To: Prof. Heng Dai
Editor, Hydrology and Earth System Sciences

Re: Revised manuscript "Joint characterization of heterogeneous conductivity fields and pumping well attributes through iterative ensemble smoother with a reduced-order modeling strategy for solute transport" (Paper EGUSPHERE-2025-5320) by Chuan-An Xia, Jiayun Li, Bill X. Hu, Alberto Guadagnini, Monica Riva.

Fig. 1 Workflow of iES_ROM, comprising (i) standard MC simulation of groundwater flow (relying on FSM), (ii) reduced-order MC approach for solute transport (relying on ROM), and (iii) iES coupled with ROM.

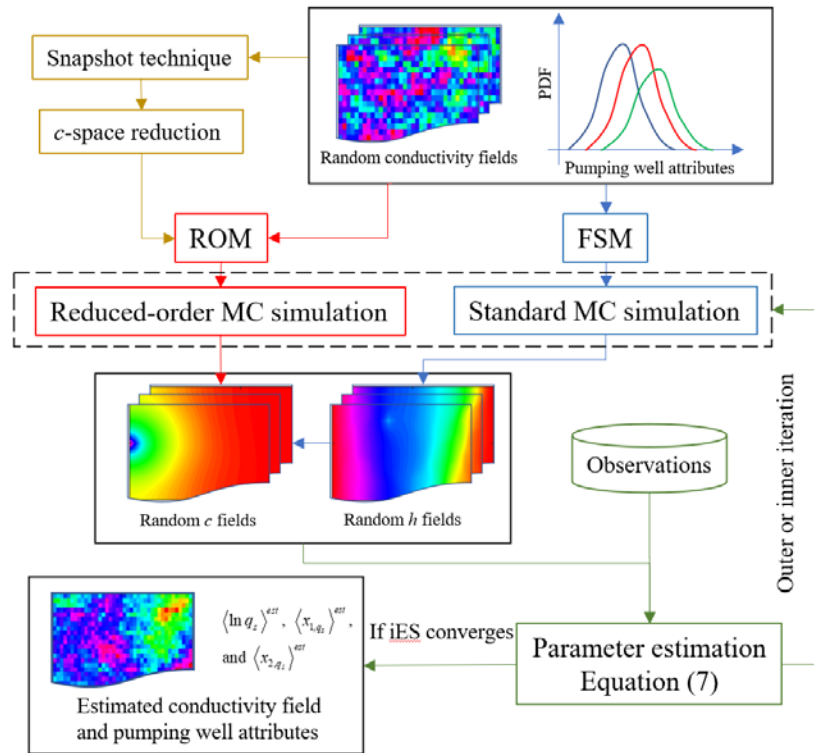
The presentation is clear and well-structured; the tables (e.g., Table 1, which serves as a roadmap for Groups A–E) and figures adequately support the conclusions. The English is generally correct and technically appropriate. Suggested improvements include condensing repetitive result descriptions, emphasizing cross-group patterns

and non-intuitive behaviors (e.g., non-monotonic trends), and adding a small workflow schematic/flowchart for iES_ROM (since the POD basis is built once and reused).

Answer: We now condense repetitive descriptions and explanations. Table 1 lists details of the five Groups analyzed, each corresponding to the analysis of a specified factor with the aim of testing the potential of iES_ROM. We have emphasized the non-monotonic trends of key metrics versus the number of outer iterations. We now add the following flowchart to clarify the conceptual and operational framework underpinning iES_ROM. We do hope these elements contribute to improve clarity.
